YORK REGION EMS #19

PROJECT: 445 HARRY WALKER PARKWAY SOUTH, NEWMARKET

**Re: Site Plan Application
1415 Harry Walker Parkway**

NOTES TO COMMITTEE

OVERALL SITE PLAN
1:500

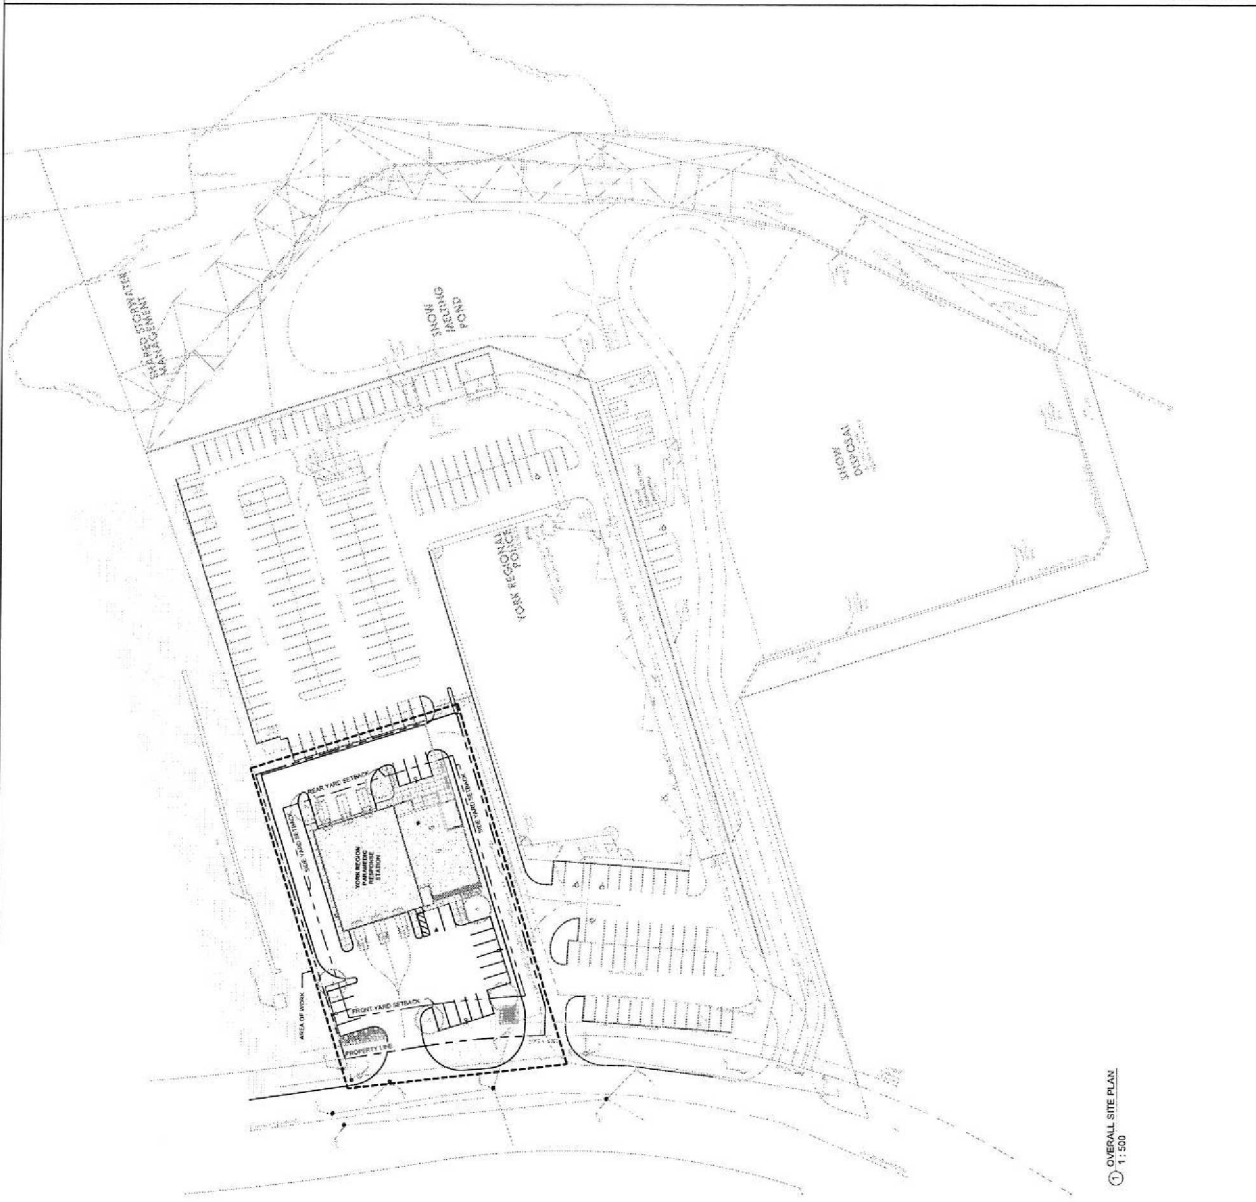
- Parking spaces along northerly property line do not meet setback requirements
- Drawings to be revised to be consistent with each other
- Additional landscaping to be provided
- Consideration to be given to installation of pedestrian walkway through site to front door
- Arborist Report and Tree Preservation Plan to be peer reviewed by Town's Consulting Arborist
- Construction Management Plan required prior to work commencing
- Public Information Centre to be held unless Committee directs otherwise
- Permit may be required from Ministry of Transportation
